## January 2017 Update Pack

This is the first 2017 update to the Part E Robust Details Handbook.

# Changes to the fourth edition following January 2017 update

## 10. Services and sockets in the separating wall

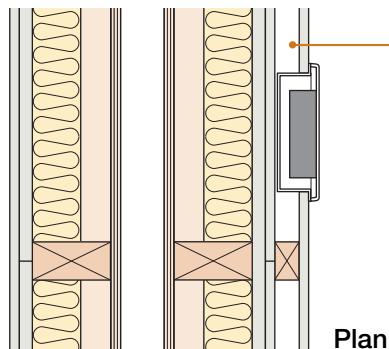
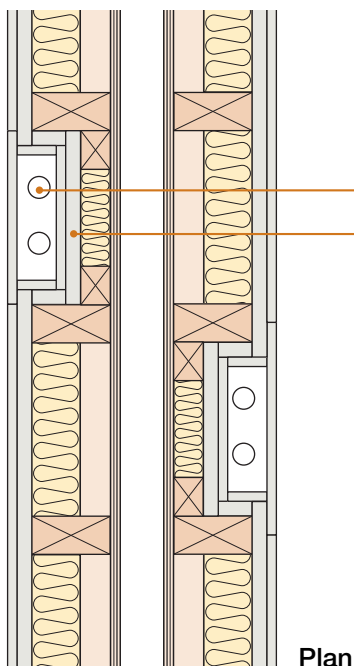
Diagram 10 7 Options 10.1 and 10.2 were referenced as 9.1 and 9.2.
